Section 40 Review and Variance of
Application No. 1515213, Class Ib Waste Disposal
Scheme, Well 00/09-01-048-14W5M
Brazeau River

Decision 2009-029: CCS Corporation, Section 40 Review and Variance of
Application No. 1515213, Class Ib Waste Disposal Scheme, Well 00/09-01-048-
14W5M, Brazeau River

**Decision 2009-029
Application No. 1553726**

Figure 1. Wellbore schematic (well 00/09-01-048-14W5M)

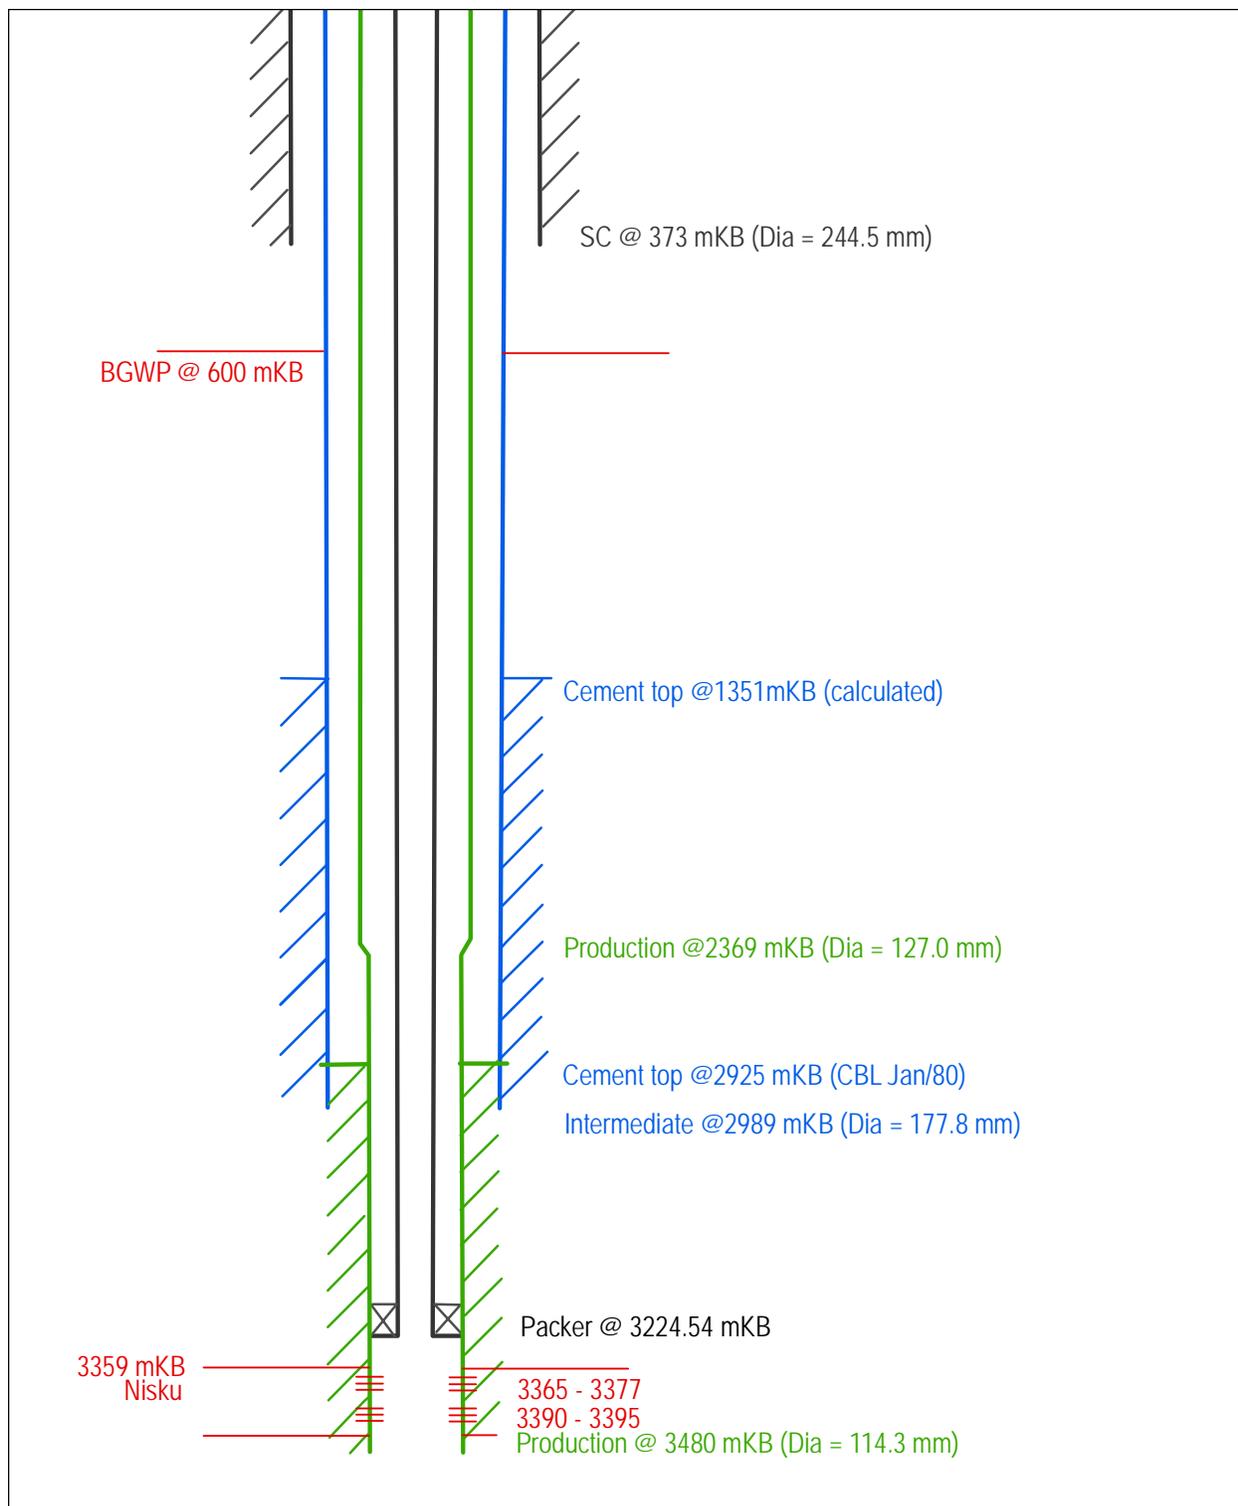
The Board notes that while cemented surface casing in the 09-01 well is set to 373 mKB, far below most domestic water wells, it does not cover to the BGWP, which is set at 600 m at this location. Based on the description of the Paskapoo/Scollard boundary from the *Geological Atlas of the Western Canada Sedimentary Basin*, the Board acknowledges that the four sands identified by CCS from 388 mKB to 650 mKB in the 09-01 well are within the Paskapoo Formation, not the Edmonton Formation. The Board does not find Edmonton salinity and permeability data to be applicable to the Paskapoo Formation sands in the 09-01 well. In the absence of conclusive data to accurately determine the salinity of the four sands in the 09-01 well, the Board accepts the current BGWP depth of 600 mGL at the 09-01 well site.

The Board notes that the intermediate casing string was not cemented full length; the interval from 373 to 1352 mKB has no cement coverage. The next casing string (production casing) was not cemented full length and has a cement top at 2925 mKB, above the intermediate casing shoe. There is tubing and a packer at 3224.54 mKB.

The Board has reviewed the existing wellbore configuration and agrees with CCS that the configuration provides a high degree of assurance that non-saline groundwater will not be contaminated by Class Ib waste fluids and is equivalent to if not better than the level of security provided by cement alone, subject to an effective program of monitoring by CCS and surveillance by ERCB staff, as discussed in Section 8. Simultaneous failures of the primary containment system (consisting of the wellhead, tubing, and packer), the production casing and intermediate casing would need to occur for the injected fluid to come into contact with the uncemented interval of the production casing. A failure of the production casing would need to occur for the injected fluid to come into contact with the uncemented interval above the BGWP. The Board further acknowledges the preventive corrosion measures that CCS has implemented to ensure casing integrity, such as the corrosion-inhibiting fluid in the annuli and cathodically protecting the casing.
